### STAFF RECOMMENDATION 209 South 5<sup>th</sup> Street December 20, 2017

**Application:** New construction—addition; Partial demolition  
**District:** Edgefield Historic Preservation Zoning Overlay  
**Council District:** 06  
**Map and Parcel Number:** 08215021100  
**Applicant:** Dave Wachtel  
**Project Lead:** Melissa Baldock, melissa.baldock@nashville.gov

**Description of Project:** Application is to remove a portion of a non-historic addition and to construct a new side addition.

Figure 4. The greenhouse structure was constructed on top of the side addition prior to 1995.

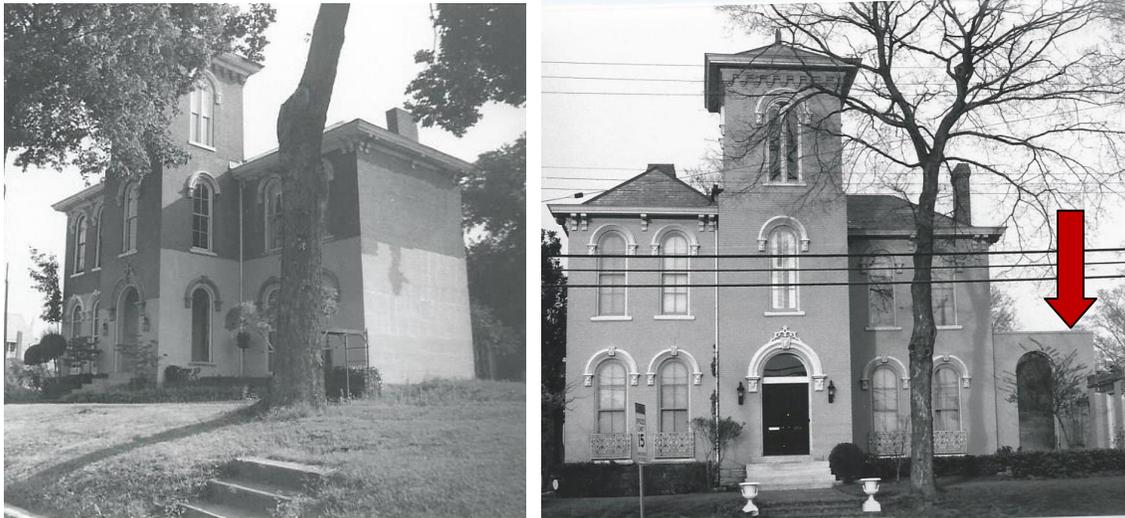
Demolition: The applicant intends to remove the glass greenhouse-type structure above the one story side addition (See Figure 4). This greenhouse structure is not historic, as it was constructed in the late 1980s or early 1990s. Staff finds that its removal will improve the historic character of the house. Staff therefore finds that the removal of the greenhouse structure meets Section V.B.2 for appropriate demolition and does not meet section V.B.1 for inappropriate demolition.

Figure 12. The red portions show the footprint of the historic house from the earliest Sanborn map in 1897 to the latest Sanborn in 1957. The yellow portions show the footprint of the addition that was added in the 1970s. The blue portion of the addition is what is proposed under this application.

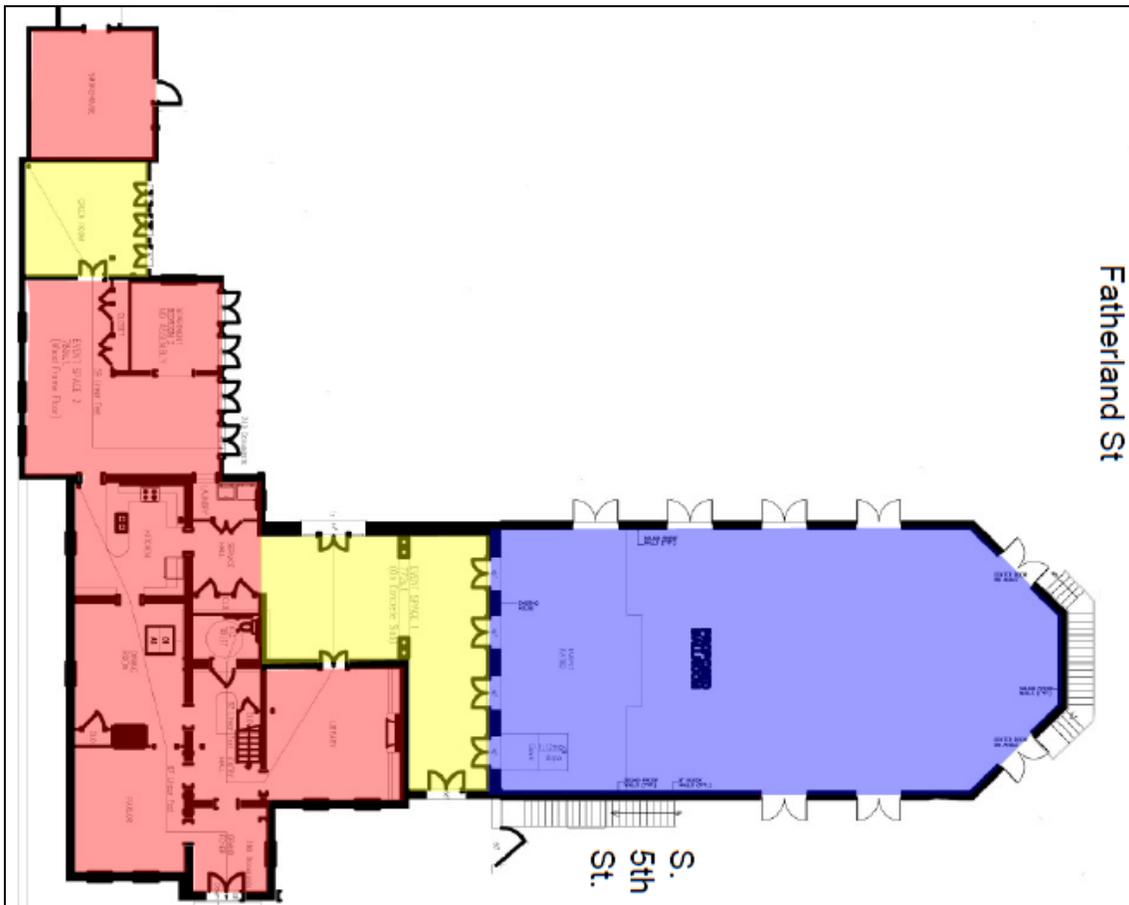
Height & Scale: Staff finds that the proposed scale for the side addition to be inappropriately large. The side addition will have a total width of seventy-six feet, four inches (76'4"), which is almost twice the width of the historic portion of the house. By comparison, the width of the historic portion of the house is approximately just forty-six feet (46') (Figure 12). Although the design guidelines do permit side additions on wide lots like this one, staff finds that the proposed side addition does not meet the guideline that side additions should be "narrower than half of the historic building width."

The design guidelines state that side additions “*should set back from the face of the historic structure (at or beyond the midpoint of the building) and should be subservient in height, width and massing to the historic structure.*” The side addition attaches on to a 1970s side addition, and it matches the one-story height of the previous addition. While the addition is significantly shorter than the historic house, its massive width and footprint render the scale of the addition inappropriate.

FIRST FLOOR PLAN

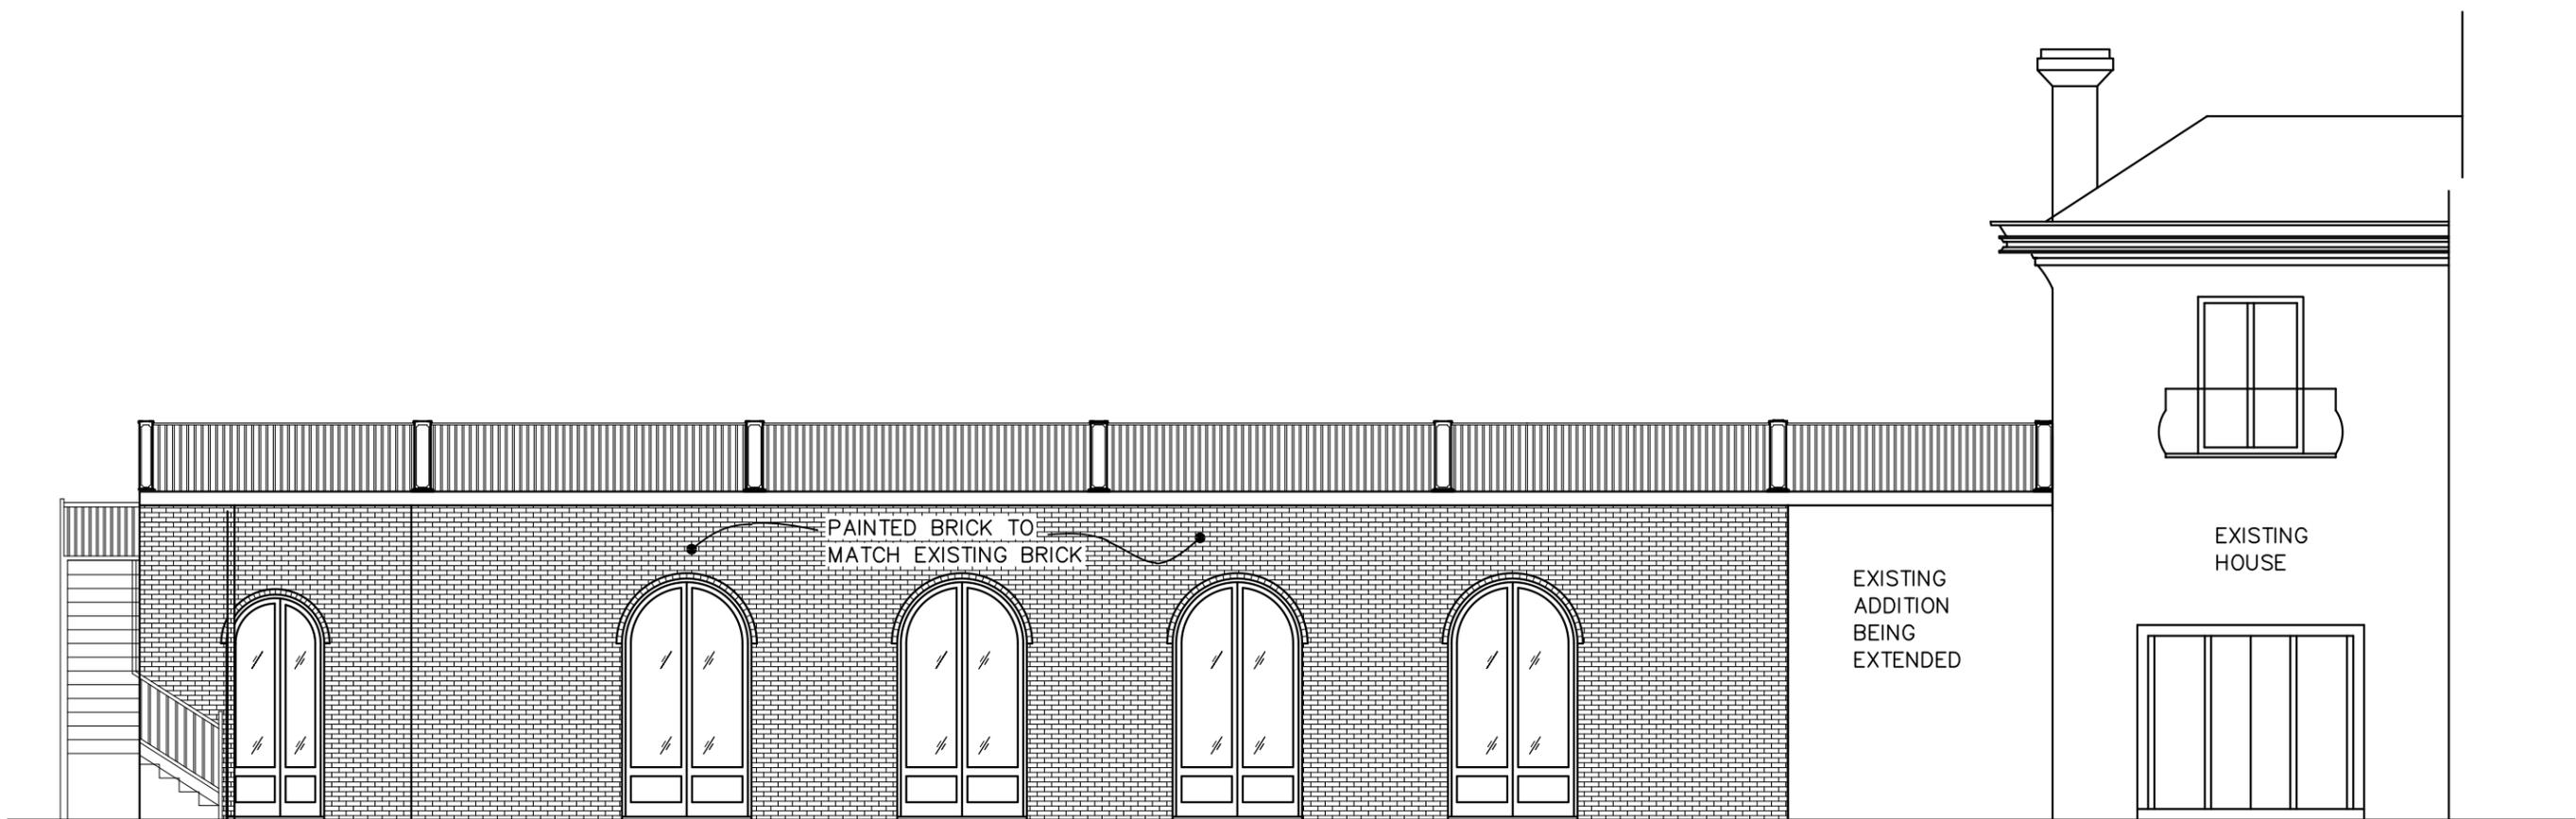
Setback & Rhythm of Spacing: The proposed addition meets all base zoning setbacks. It will be approximately sixty-two feet (62’) from the left property line, twenty-five feet (25’) from the right property line, and over one hundred and seventy feet (170’) from the rear property line. Even though the addition meets the base zoning setbacks, staff finds

that it interrupts the rhythm of spacing along this section of South 5<sup>th</sup> Street. As the Sanborn maps show, historically there were two to three houses on this section of South 5<sup>th</sup> Street, all oriented towards South 5<sup>th</sup> Street. The side “ballroom” addition transforms the house and the lot into something they were not historically. Historically, this block had a collection of larger city homes on urban-size lots. The side “ballroom” addition prevents the historic rhythm of spacing of houses to be reestablished in the future with infill development. Further, it tries to make the house into a grand estate on an over-sized lot, which was not its historic use or intention. Staff finds while the setbacks meet the base zoning setbacks, the addition’s rhythm of spacing does meet section III.B.2.a. of the design guidelines.

**PROPOSED FRONT ELEVATION**

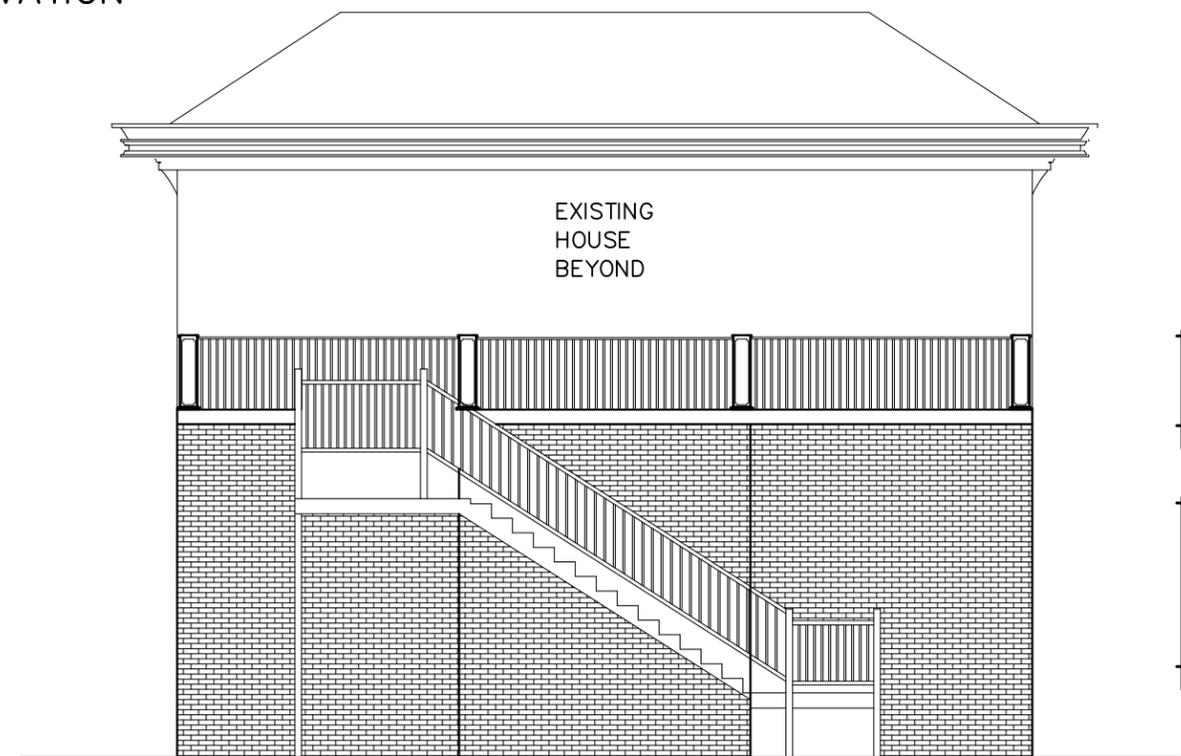
Staff also finds that the two exterior stairs, one on the South 5<sup>th</sup> Street façade and one on the Fatherland façade are not appropriate. Historically, stairs were internal, or if they were utilitarian, were located on the rear façade.

Proportion and Rhythm of Openings: No changes to the window and door openings on the existing house were indicated on the plans. The openings on the addition are arched French doors. There is an expanse of approximately thirty-five feet (35') on the front of the addition, facing South 5<sup>th</sup> Street, without a window or door opening. Staff finds that this expanse does not meet the design guidelines, which state that there should be a door or window opening every eight to thirteen feet (8'-13'). Staff finds that the project's proportion and rhythm of openings do not meet Section III.B.2.f. of the design guidelines.

PROPOSED REAR ELEVATION FROM 5TH STREET  
W/BRICK WALL SHOWN

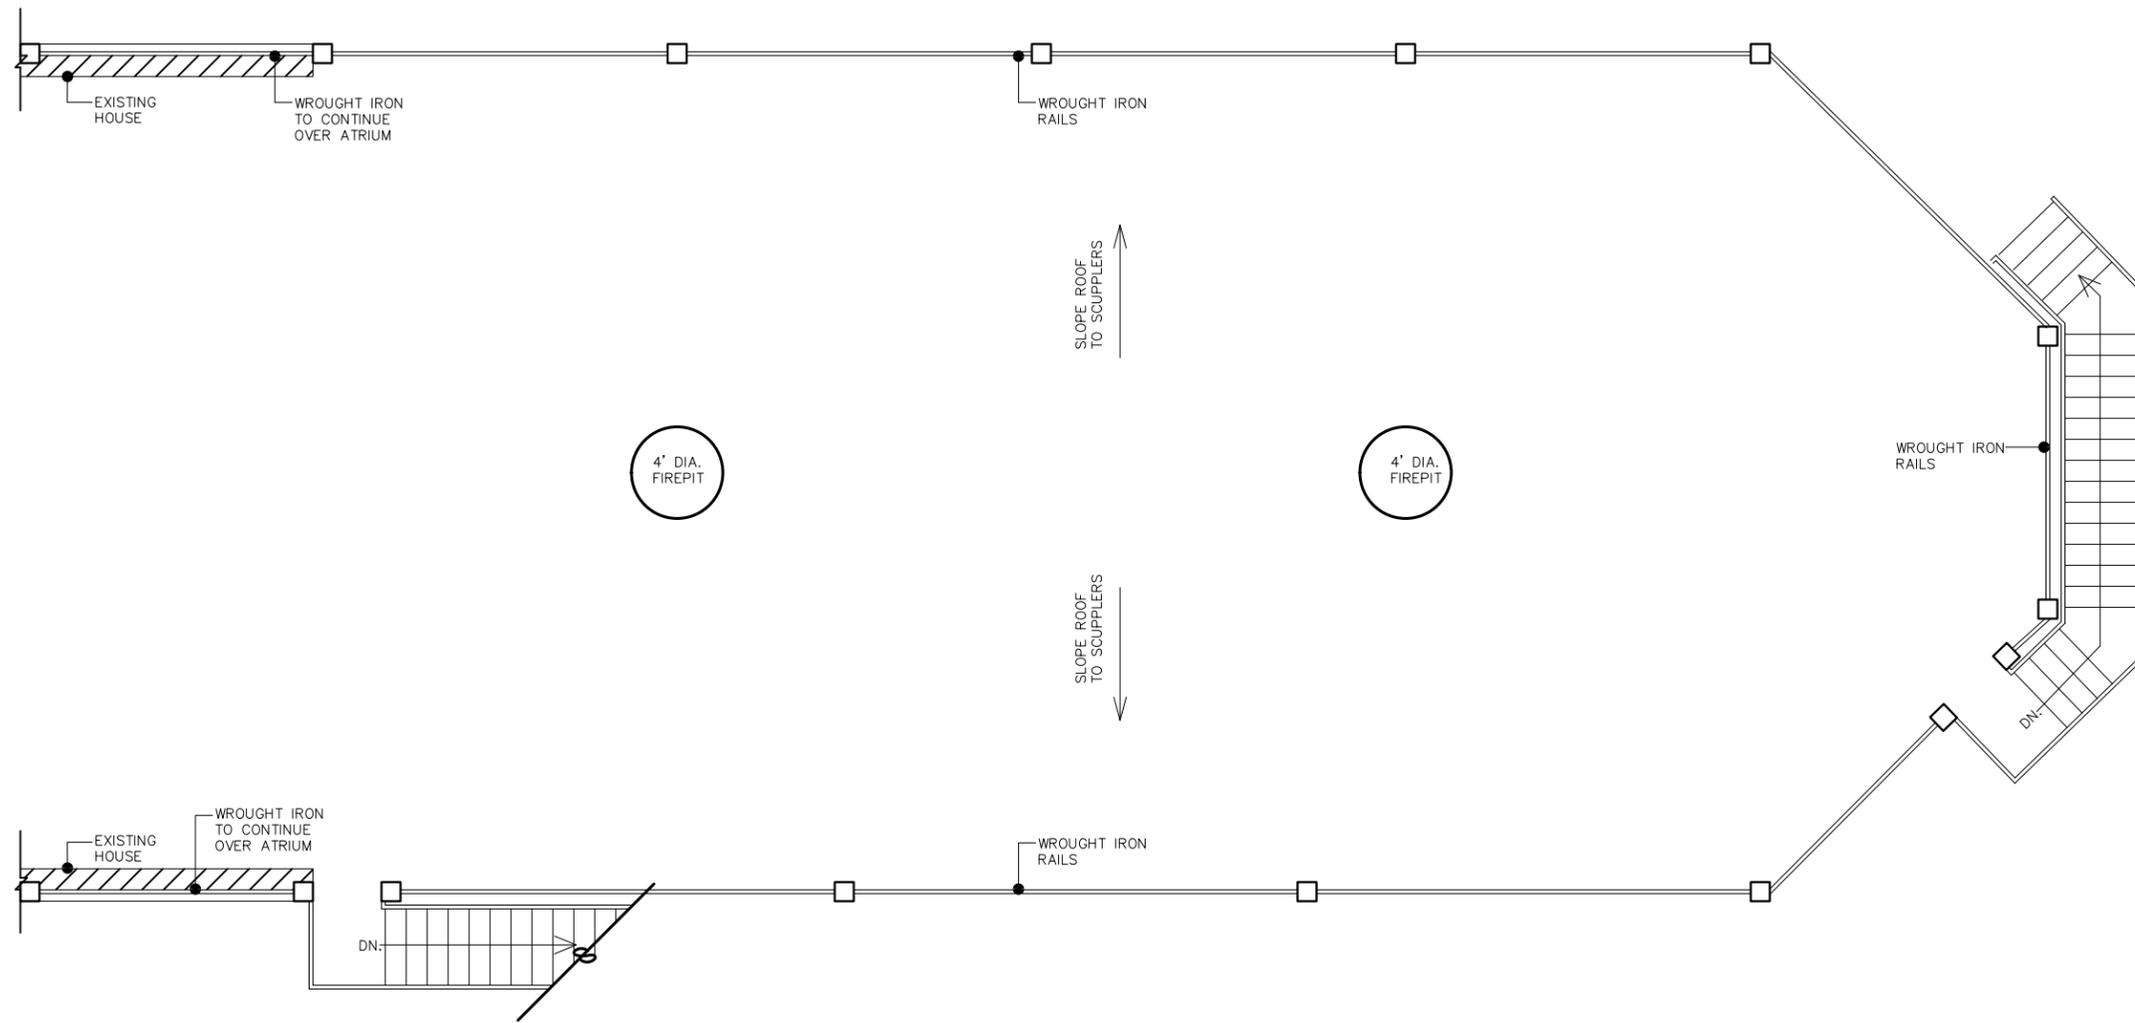
Although the applicant maintains that the addition will not be highly visible from the street because of the brick wall and the landscaping, staff counters that the brick wall was constructed in the 1980s and therefore not historic. Both the brick wall and the landscaping could be easily removed, and if they were, the addition would be highly visible from both South 5<sup>th</sup> Street and Fatherland Street. In the past the Commission has not used fences/walls or landscaping when determining “visibility.”
